**NOTICE OF A REGULAR MEETING
BONDURANT PLANNING AND ZONING COMMISSION
MARCH 28, 2019**

PLANNING AND ZONING COMMISSION
RESOLUTION NO. PZ-190314-07

Prepared by: Marketa Oliver, City Administrator, incorporating
information from Beth Richmond at HGKI
March 25, 2019

BONDURANT, IOWA
BONDURANT COMMERCIAL - LOT 7
SITE PLAN REVIEW

BONDURANT COMMERCIAL - LOT 7

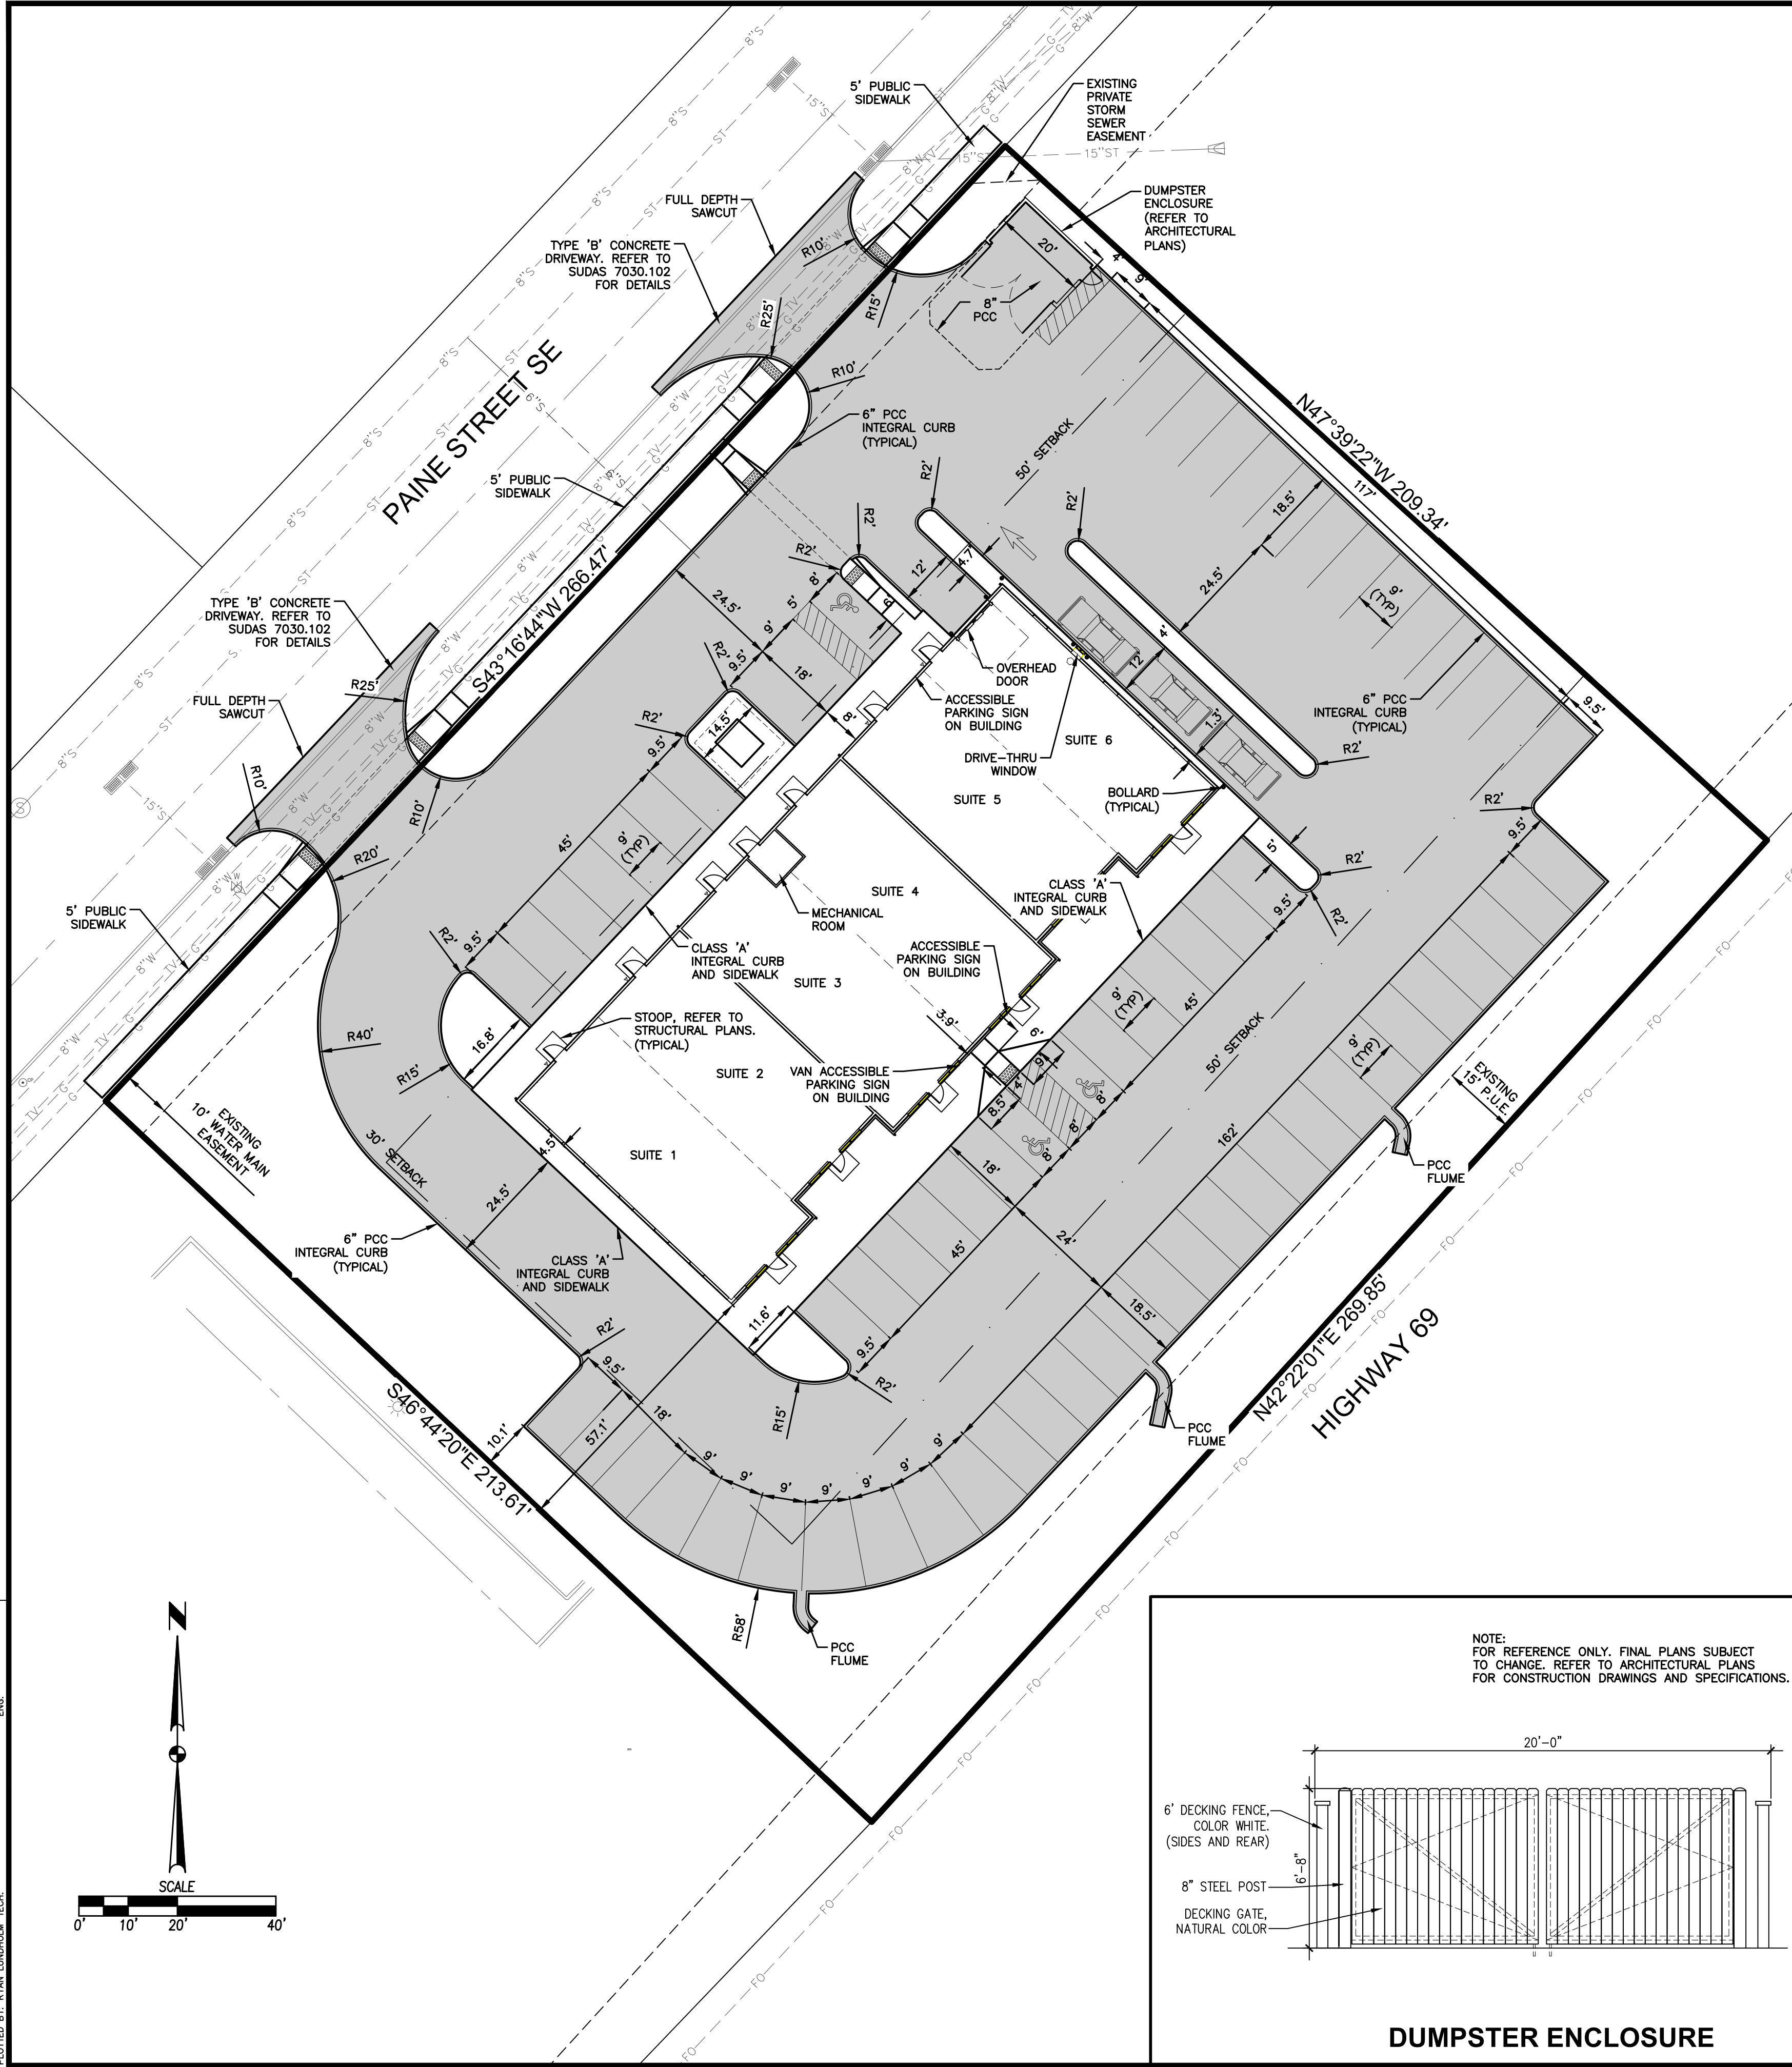
Currently, there are not enough spaces provided for the drive-in window if the window were to be used as a typical drive-through. 5 spaces are usually required for each drive-through window but the site plan only shows room for three cars. However, due to the usage for this window in a way that is not the convention “drive-through” window, three spaces are acceptable.

On the site plan, the applicant has provided a 12-foot wide drive-up lane which meets requirements. This lane is separated from normal circulation routes on the site and is marked by appropriate pavement markings. Any drive-through speaker proposed in the future may not reach volumes higher than 50 decibels and may not be audible above daytime ambient noise levels beyond the property lines of the site.

On the current site plan, only 60 feet of stacking space is provided. The Zoning Administrator has deemed that adequate stacking is available for this type of drive-through.

1. The zoning is shown on the site plan as C-2 Central Commercial District.
2. The site plan illustrates a six unit commercial building. The site plan indicates a drive-thru window on the northeasterly side of the building on Suite 6.

3. The parking requirement is calculated based on four of the six suites meeting the requirements for restaurant space and two suites meeting the requirement for business and professional office space. The parking requirement calculates to 68 spaces. A total of 68 spaces are shown on the site plan.

4. The site plan would meet the parking requirements as long as no more than four suites are used for a restaurant or similar use.
5. The site plan under general notes includes a reference that will comply with the 2019 Edition of SUDAS. This note is satisfactory.

EROSION AND SEDIMENT CONTROL PLAN

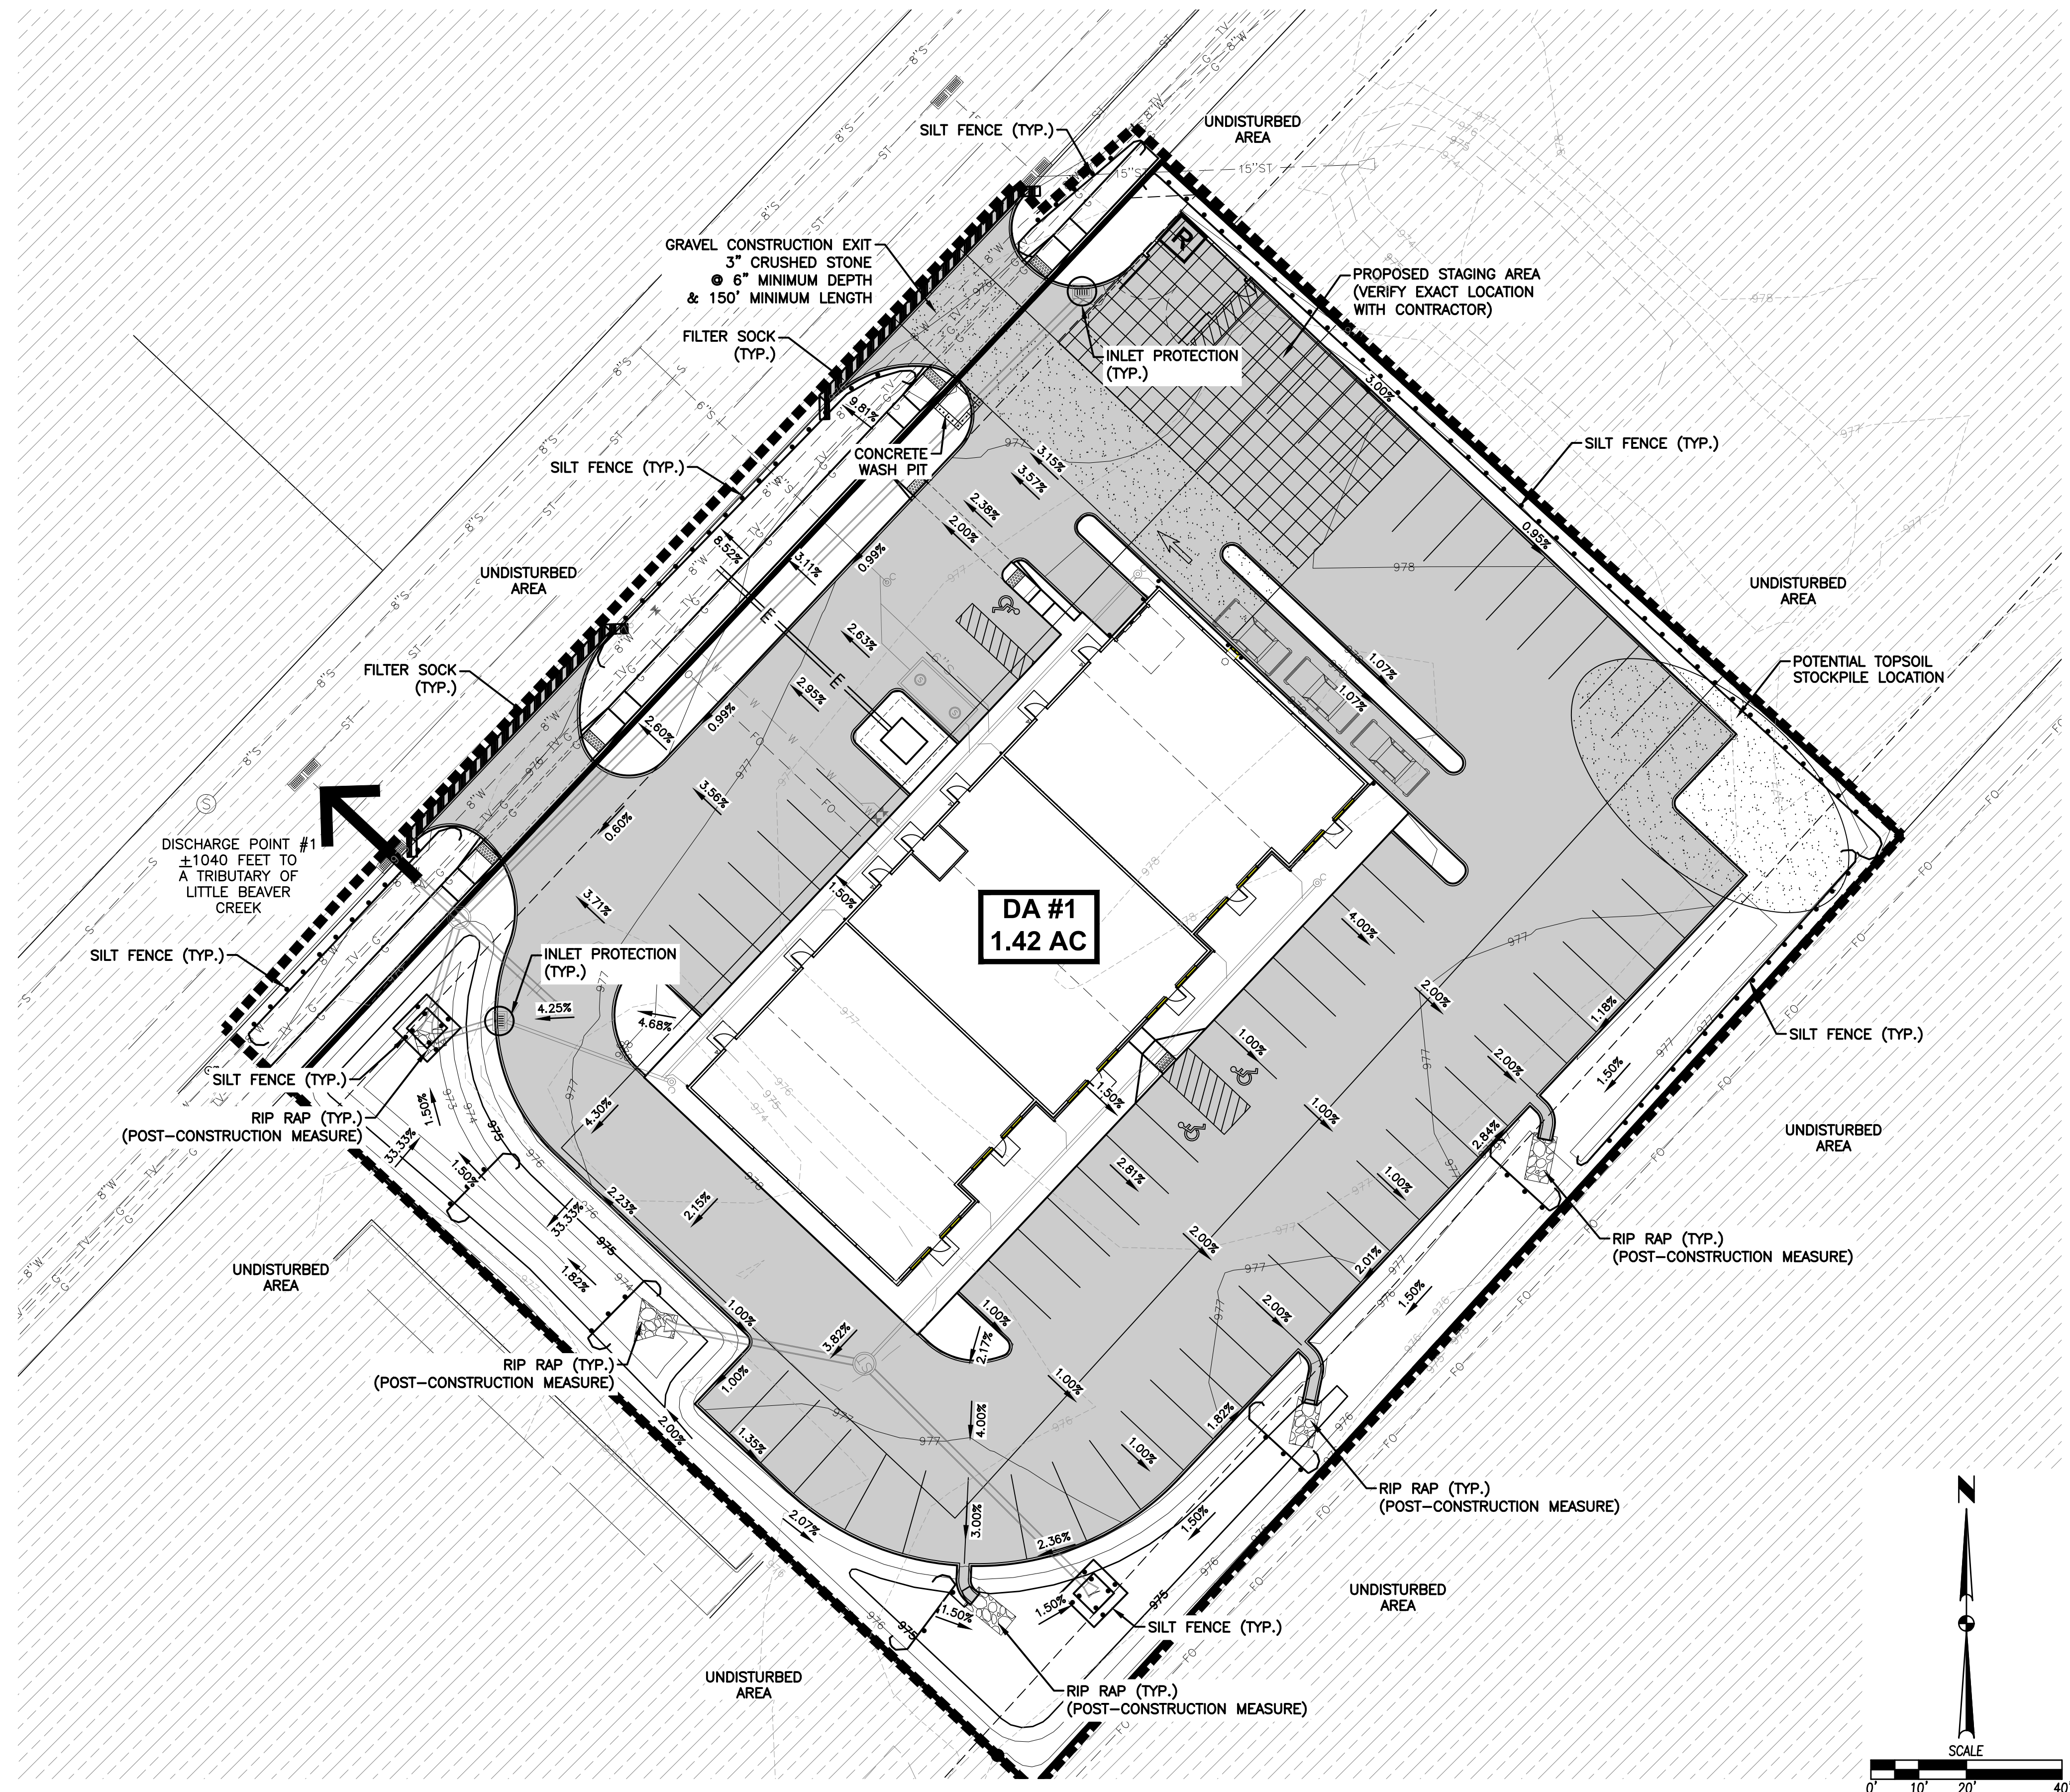
19. The site disturbs more than one acre and a General Permit No. 2 and Storm Water Pollution Prevention Plan is required for the project. The site plan includes a basic erosion and sediment control plan. The additional documents required for the full Storm Water Pollution Prevention Plan (SWPPP), including General Permit No. 2 will need to be submitted to the City prior to the start of construction.
